#### 194th session

## Proposal for Supplement 1 to the 06 Series of Amendments to UN Regulation No. 110 (Compressed Natural Gas and Liquefied Natural Gas Vehicle)

### Submitted by the Working Party on General Safety Provisions\*

#### Example 2

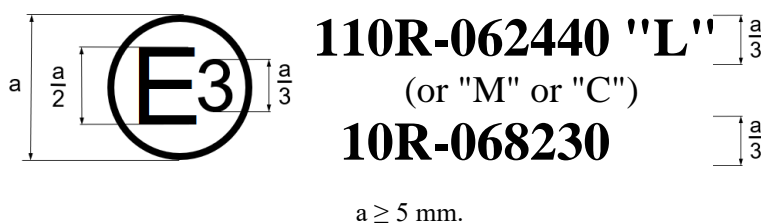
Annex 2A, amend to read:

(See paragraph 7.4.3. of this Regulation)

This approval mark when affixed to the CNG and or LNG component shows that the component has been approved in Italy (E 3), pursuant to UN Regulation No. 110 under

approval number 062440 and pursuant to UN Regulation No. 10<sup>1</sup> under approval number 068230. The first two digits of the first approval number indicate that the approval was granted in accordance with the requirements of UN Regulation No. 110 as amended by the 06 series of amendments.

The first two digits of the second approval number indicate that the approval was granted in accordance with the requirements of UN Regulation No. 10 as amended by the 06 series of amendments."
